## Access Compliance Report Public Rights-of-Way (Curb Ramps)

Intersection ID: 10020349 Main Street: BALLANTYNE\_COMMONS\_PY Cross Street: N/A Location: NW

ADA ID: 7198BCFF3617 Ramp Type: Perp Initial Pass/Fail: Fail Overall Compliance: No Severity Score: 33.75

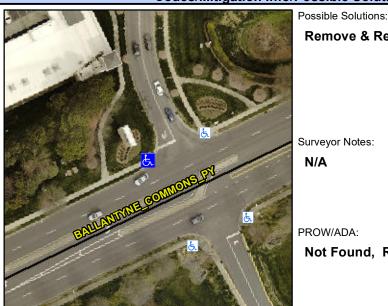
N/A	Ramp Length (in)	64.0	No	Ramp Slope (%)	13.2
No	Ramp Width (in)	47.0	Yes	Ramp XSlope (%)	0.2
N/A	Flare Type LT	N/A	N/A	Flare Type RT	N/A
N/A	Flare Slope LT (%)	N/A	N/A	Flare Slope RT (%)	N/A
N/A	Flare Traversable LT?	N/A	N/A	Flare Traversable RT?	N/A
N/A	Landing Length (in)	N/A	N/A	DWS Provided?	N/A
N/A	Landing Width (in)	N/A	N/A	DWS Contrast?	N/A
N/A	Landing Slope (%)	N/A	N/A	DWS Length (in)	N/A
N/A	Landing X Slope (%)	N/A	N/A	DWS Full Width?	N/A
N/A	Landing Curb? (Y/N)	N/A	N/A	DWS Offset (in)	N/A
N/A	Shared Landing?	N/A			
N/A	Gutter Ponding?	N/A	N/A	Gutter Slope (%)	N/A
N/A	Gutter Lip Ht (in)	N/A	N/A	Gutter X Slope (%)	N/A
N/A	Painted X Walk1?	No	N/A	Painted X Walk2?	N/A
	X Walk 1 Direction	То Е		X Walk 2 Direction	N/A
N/A	X Walk 1 Width (in)	N/A	N/A	X Walk 2 Width (in)	N/A
	X Walk 1 Slope (%)	4.9		X Walk 2 Slope (%)	N/A
	X Walk 1 X Slope (%)	4.5		X Walk 2 X Slope (%)	N/A
N/A	Ramp inside XWalk1?	N/A	N/A	Ramp inside XWalk2?	N/A

Fussible Solutions.
Remove & Replace Entire Ramp.
·
Surveyor Notes:
N/A
PROW/ADA:
Not Found, R304.5.1, R304.2.2
Not i Guila, 1004.5.1, 1004.2.2
